**Mount Pleasant Open Cut Coal Mine - Modification 4 Rail Infrastructure (DA 92/97)
Flood Impact Assessment and Independent Review**

Rail Modification Flood Impact Assessment (MOD 4)

Rail Modification Flood Impact Assessment

The aim of this report is to provide an independent desktop review of the WRM Report 0744-01-K4, dated 29 May 2020 and titled: Pleasant Rail Loop Stage 2 – Rail Modification Flood Impact Assessment Report. The aim of the Flood Impact Assessment Report (WRM, 2020) was to assess the potential impacts of the proposed rail spur on Hunter River and to determine if the final design meets the performance criteria specified in condition 44C of the MOD4 consent. The WRM (2020) flood impact assessment report includes detailed hydrologic and hydraulic modelling of the Hunter River floodplain in the area of interest, which is used to assess the potential impacts of the proposed rail spur on flood levels and velocities.

Figure 2-2: Hydrographs at Muswellbrook (WRM, 2020)

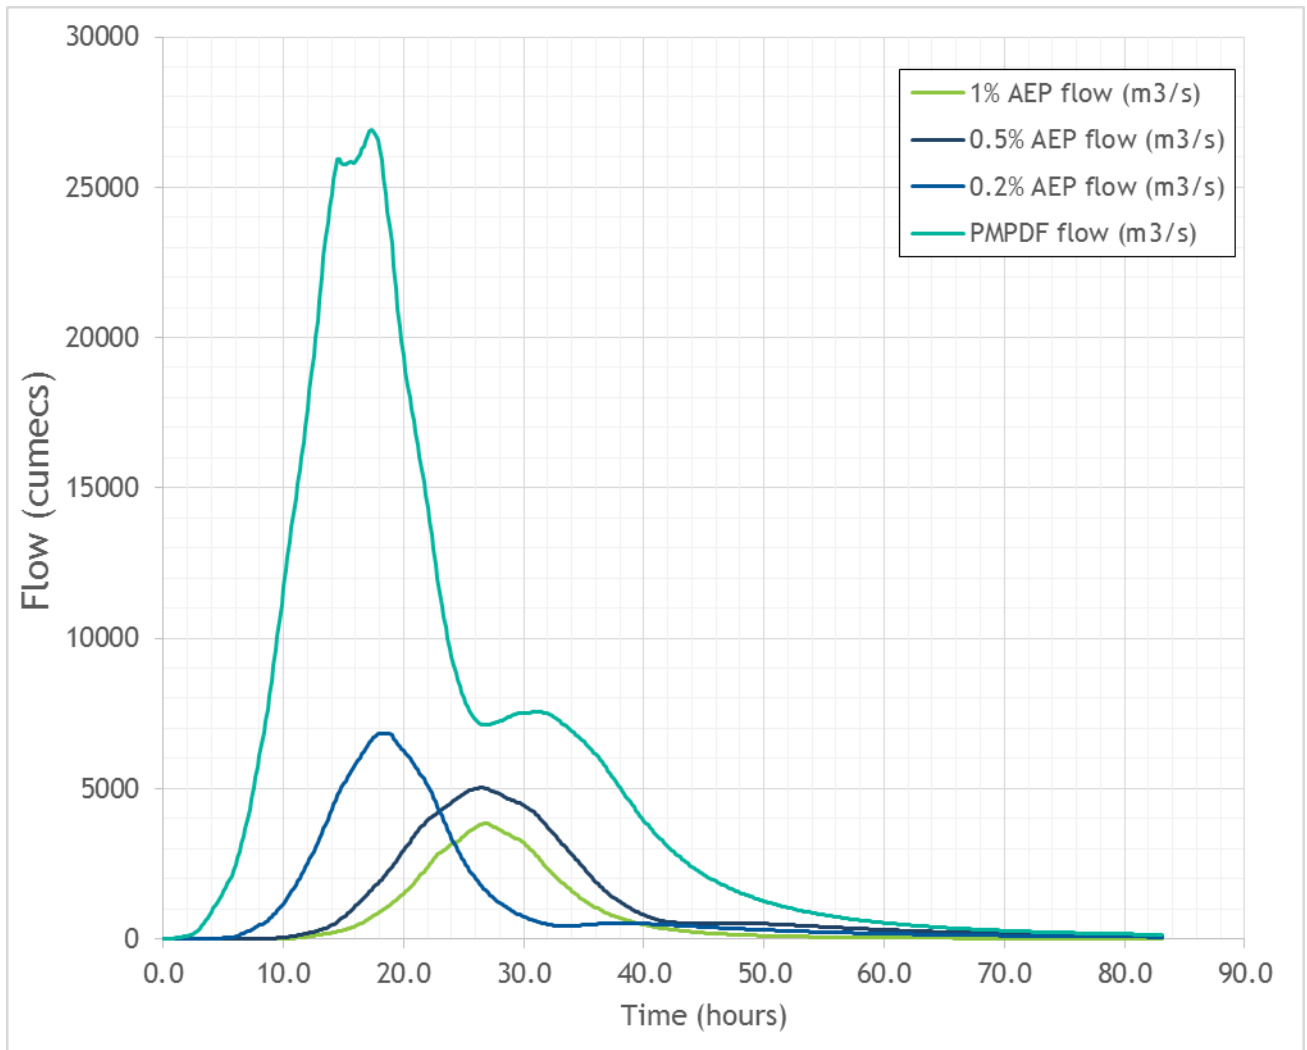
Critical Duration	No information on the resulting critical duration is specified in the WRM (2020) report, however from Figure 2-2 it is apparent that the 36 hour duration was used for the 1% and 0.5% AEP, while the 24 hour event was used for the 0.2% AEP. RHDHV (2017) found that the 24 hour rainfall event was the critical duration. This may be due to difference in the XP-RAFTS model, most likely the use of a different Bx factor (refer Section 2.3.2). The slightly longer duration (and hence higher volume) hydrograph may produce a slightly higher flood level estimate in the WRM (2020) assessment.
Extreme Event / PMF	No information on the PMP/PMF is provided in the WRM (2020) report. It is assumed to be the same used in Worley Parsons (2014) and if so, is considered appropriate. The adopted PMF hydrograph is presented in Figure 2-2.

Figure 3-1: Hunter River TUFLOW model configuration (Fig 5.1 WRM (2020))

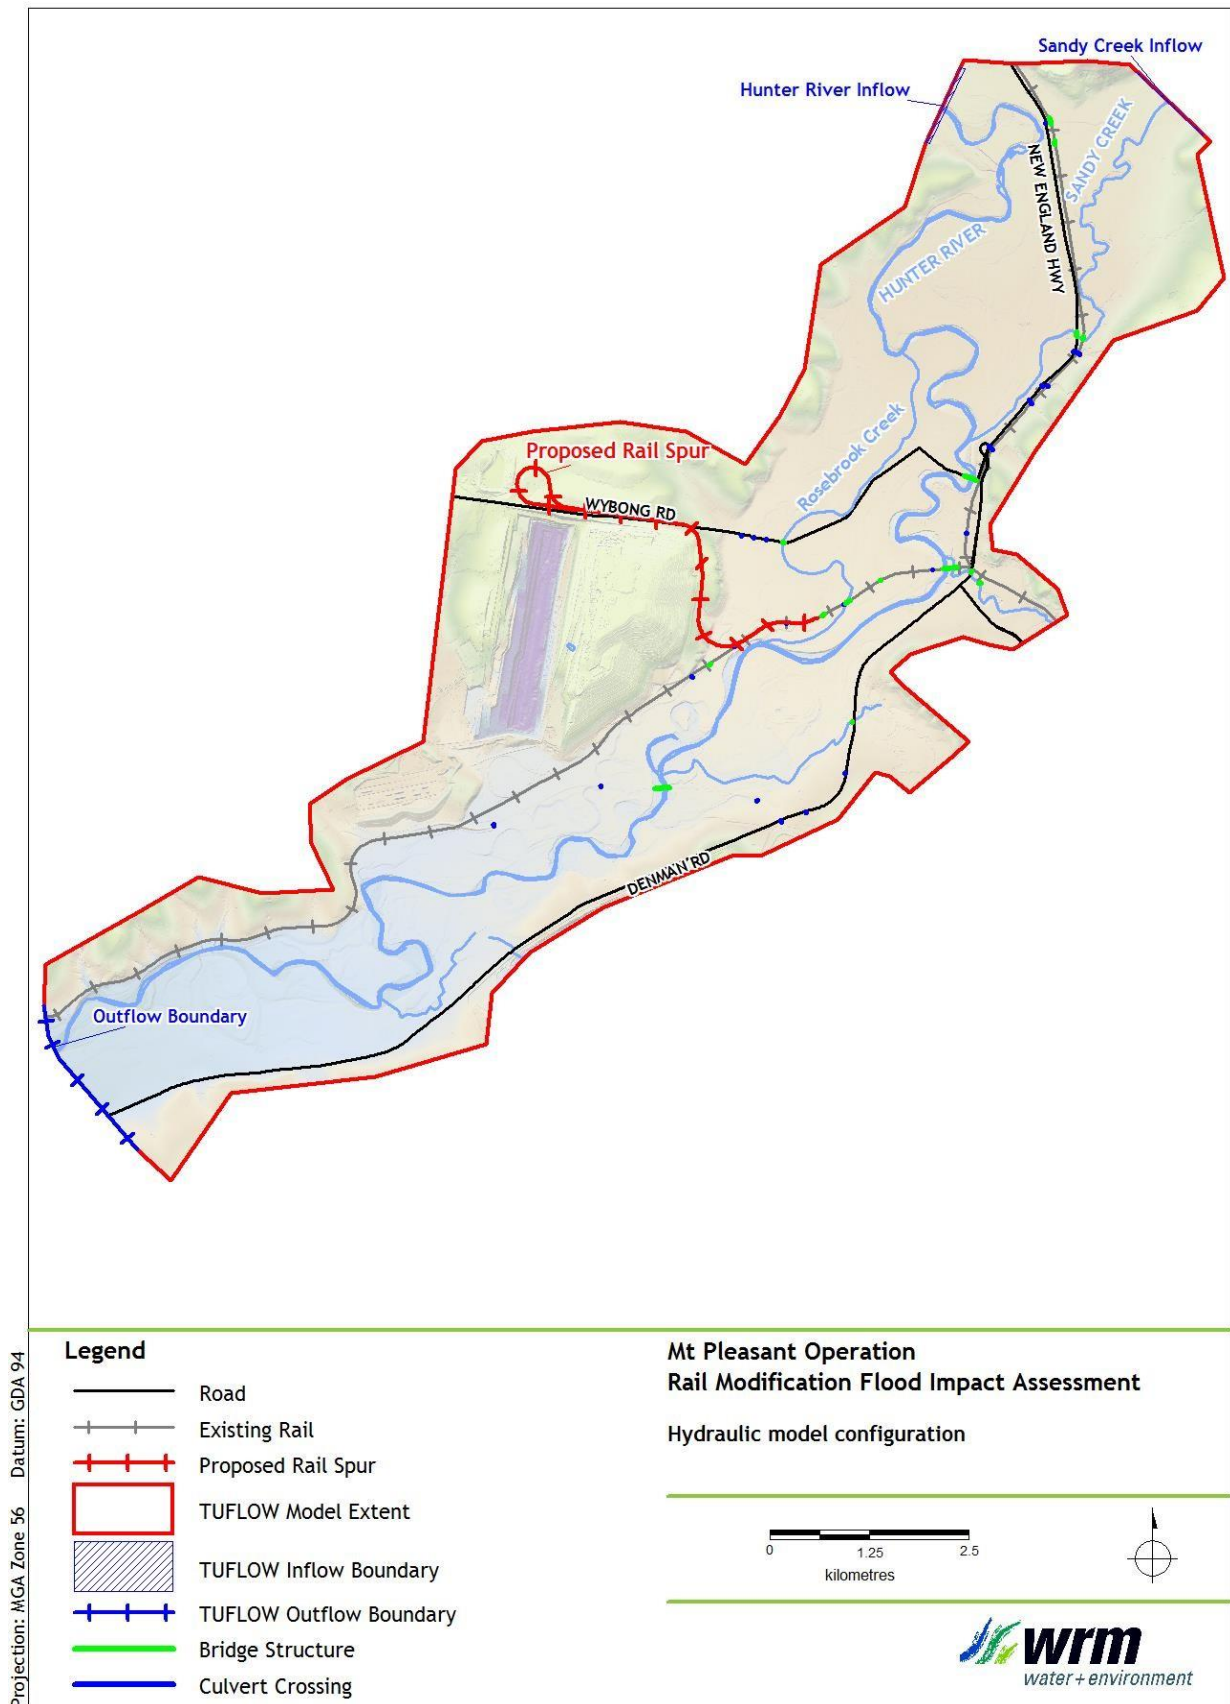
Review Element	Comment
Model Extents	The model extents are considered appropriate for the study area although are slightly smaller than that used in RHDHV (2017).
Model Resolution	A 5 metre grid resolution is considered appropriate for the study area and provides sufficient spatial resolution for the modelling assessment.
Inflow Boundary	Design inflows for the Hunter River were reviewed in Chapter 2 and appear appropriate. Calibration and validation event inflow are based on observed discharges so are assumed to be correct.
Downstream Boundary	A single normal depth outflow boundary was adopted for the Hunter River model. The outflow boundary of this model is located approximately 13 km downstream of the Rail Spur and as such would not impact on peak flood levels at the Project area. This is considered appropriate.
Elevation Data	Topographic data for the hydraulic model used elevation data based on LiDAR flown in August 2016. It is assumed this data is correct and appropriate. However, it is important to note that the LiDAR may not be able to accurately represent the channel bathymetry of deeper channel pools where standing water is present. RHDHV (2017) lowered pools by up to 2 metres to better represent observed channel stage-discharge characteristics.

Surface Roughness	A detailed discussion of the adopted hydraulic roughness (Manning's 'n') is presented in Section 3.1.3 of this report. Overall the range of values are considered appropriate.
Structures	Adopted hydraulic structures used in the hydraulic model are discussed in Section 5.2.5 of WRM (2020). Survey information on the existing hydraulic structures including culvert crossings and bridges were provided by FYFE (surveyors) dated 15 November 2017. A total of 26 culvert structures and 16 bridge structures were included in the hydraulic model based on the survey information. Figure 3-1 shows the locations of the modelled culvert and bridge structures.
Calibration/validation	The Hunter River hydraulic model was calibrated/validated to the available observed data for the 1998 and 2000 flood event. Observed flows were applied to the model with a 1.5 hour lag used to account for shift in location to the model boundary. The expected good match between observed and model flows is presented in Figure 3-2. The TUFLOW model was able to reproduce observed peak flood levels (see Figure 3-3) to within between 0.1metres for both events. However, away from the flood peak, differences in water levels of greater than 0.5 metres indicate issues with the WRM (2020) model channel stage-discharge characteristics. This may be due to the LiDAR based elevation data not accurately defining the channel bed in channel pool areas (noted above) and also slight overestimation of bank vegetation channel roughness (for

Figure 3-2: Comparison of recorded and predicted flow hydrographs, Hunter River at Muswellbrook Bridge, August 1998 flood event

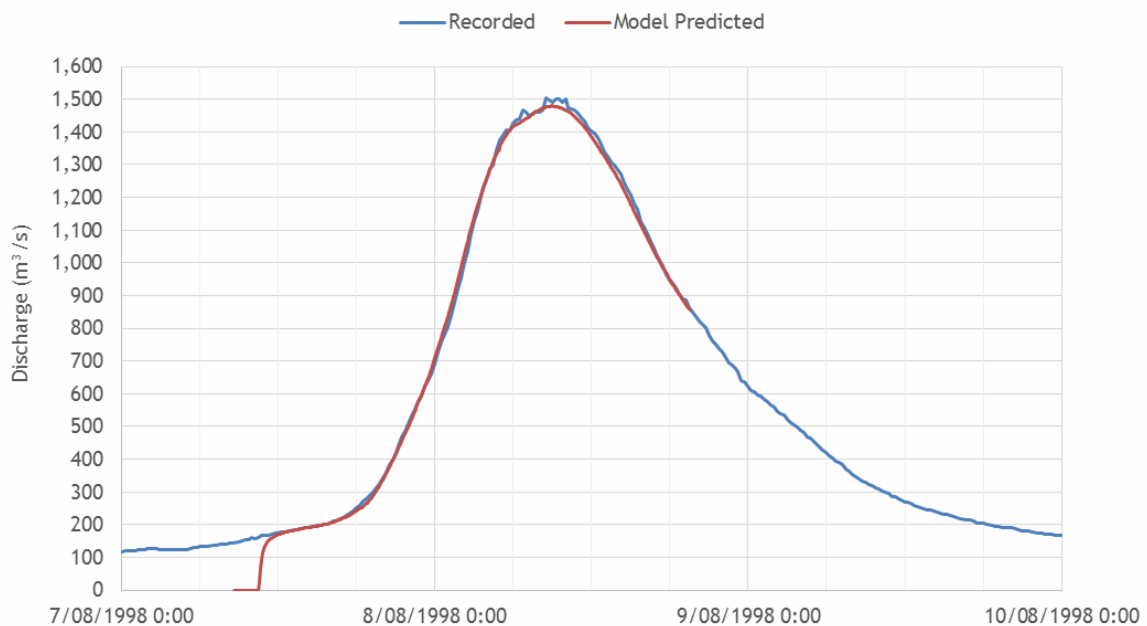
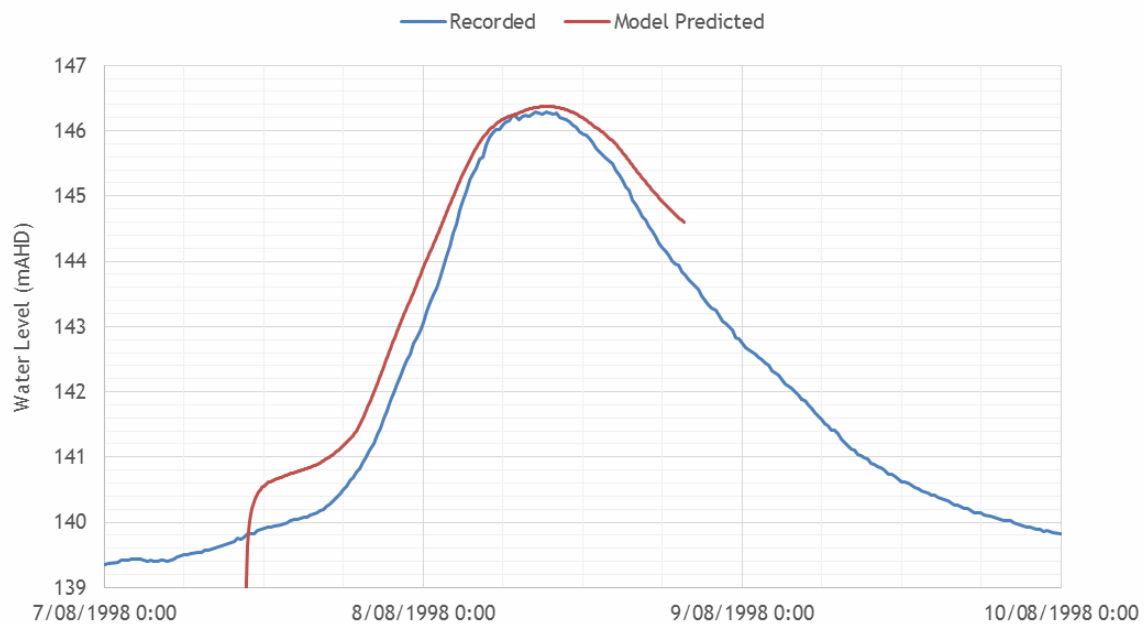
Review Element	Comment
	<p>pre 2000 conditions).</p> <p>While a good match to peak water levels was achieved it is important to recognise that changes to near bank channel vegetation mean that the channel stage-discharge characteristics have changed between 2000 and 2015 (RHDHV, 2017). This is further discussed in Section 3.1.3 of this report.</p>
Proposed Conditions Model Updates	<p>Section 6.1 to Section 6.3 of WRM (2020) provides some detail of the updates to the model required to represent the proposed conditions which included:</p> <ul style="list-style-type: none"> incorporation of an earthworks (i.e. elevation data) model into the hydraulic model, and incorporation of conceptual mitigation measure into the model which included: the extension of two existing railway culvert crossings and two bridge openings of 105 metres and 90 metres with assumed 15 metre span lengths. <p>Provided the structures were incorporated using appropriate loss parameters the schematisation of the concept rail spur it is considered a suitable tool for quantifying the potential impact. If the final design is different from the concept it should be re-assessed in the model.</p>

Figure 3-4: Rating Curve data and RHDHV (2017) Model Results (Muswellbrook Gauge: 21002)

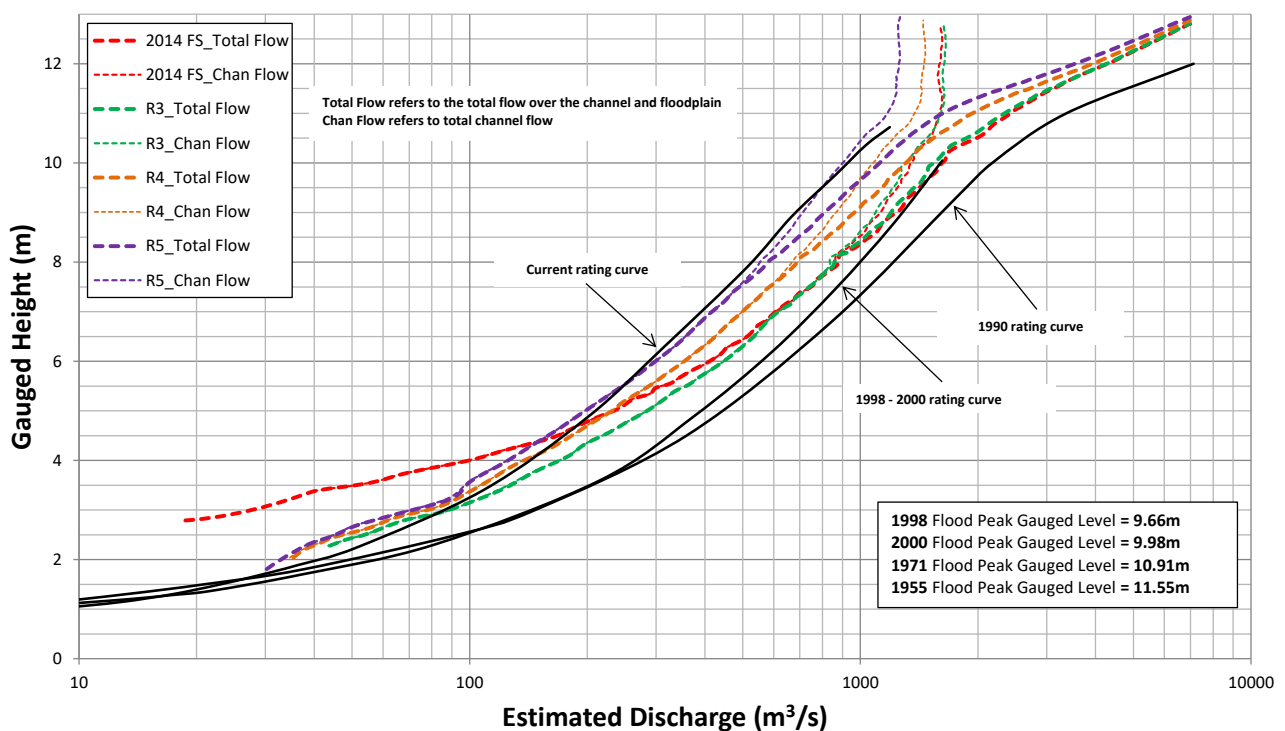
Subsequent to that review being completed, OEH were made aware that rating curves for many of the Upper Hunter stream gauges had been recently revised by NSW Office of Water (NOW). The revised rating curves substantially reduce the estimated flow rate for a given stage height at the gauging location. The revisions are due to the increase in vegetation densities both within the channel and on the channel banks over the last two decades (see Figure 3-4).

An example of the review and modelling of rating curve changes in RHDHV (2017) is presented in Figure 3-4.

Figure 3-5: Hunter River TUFLOW model Roughness Distribution (WRM (2020))

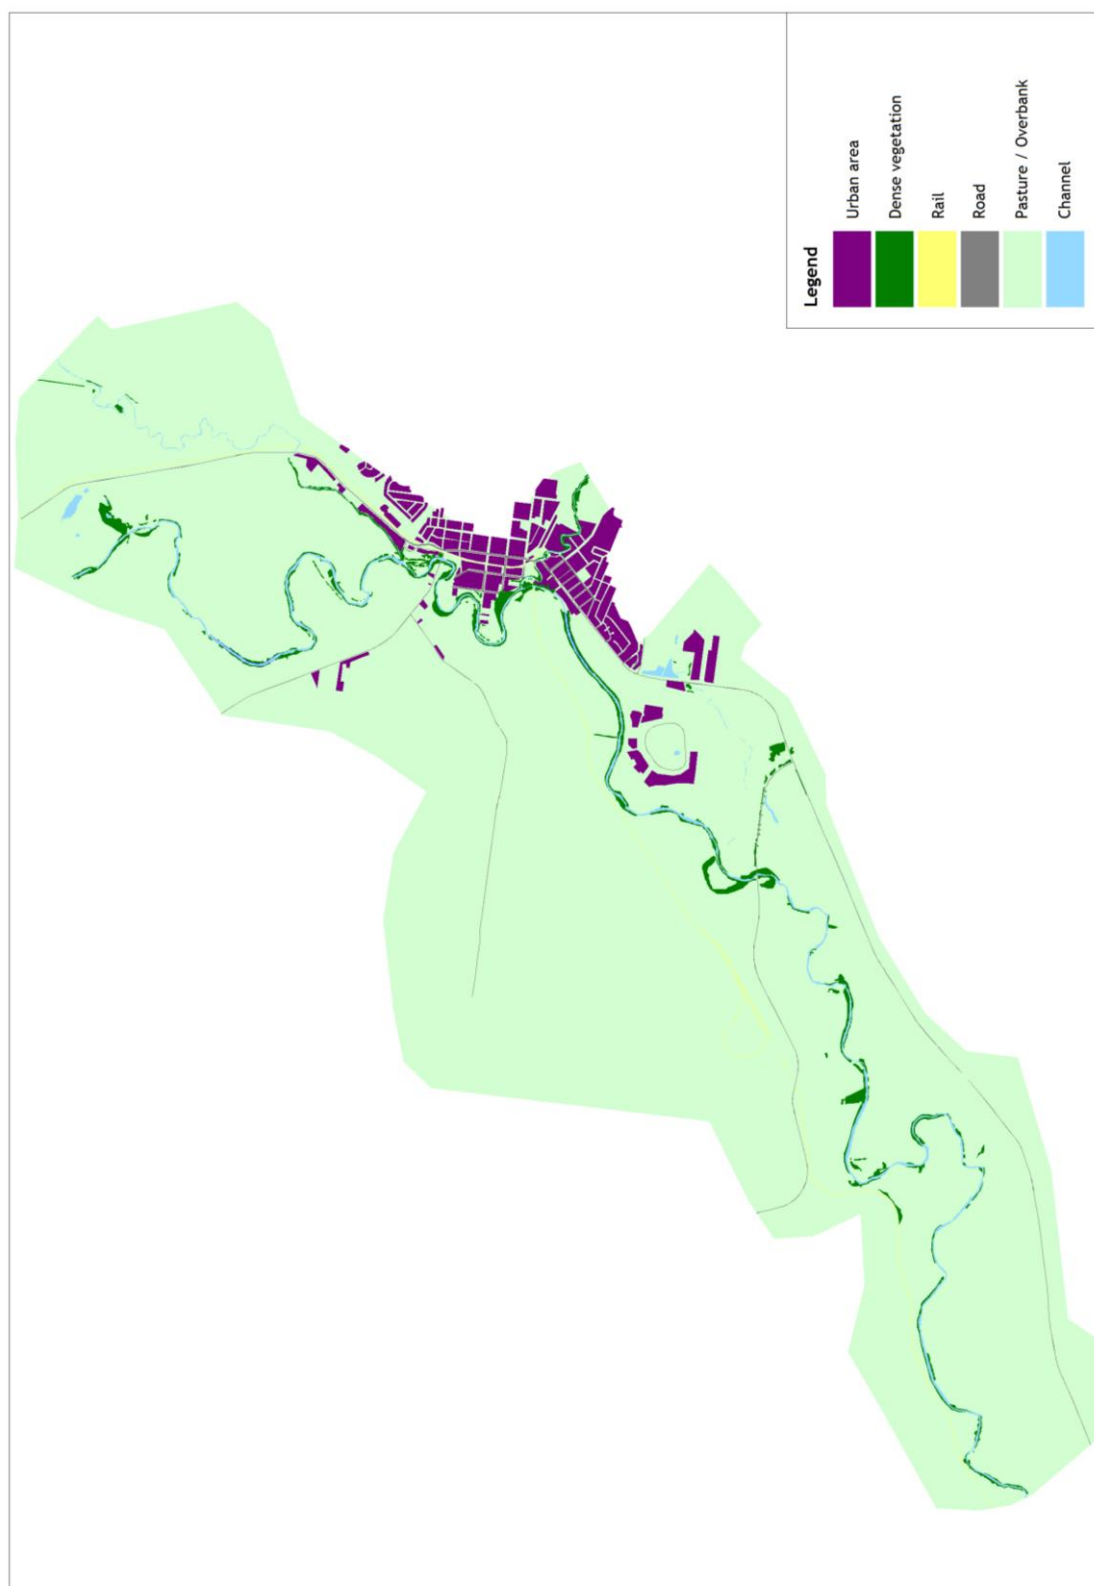
A comparison of the adopted roughness values used in the three recent flood studies (i.e. WRM (2020), WorleyParsons (2014) and RHDHV (2017)) is presented in Table 3-2. The spatial distribution of material roughness (land uses and surface types) is presented in Figure 3-5. It appears consistent with that adopted in RHDHV (2017) and includes a representation of bank channel vegetation that was omitted from Worley Parsons (2017) model.
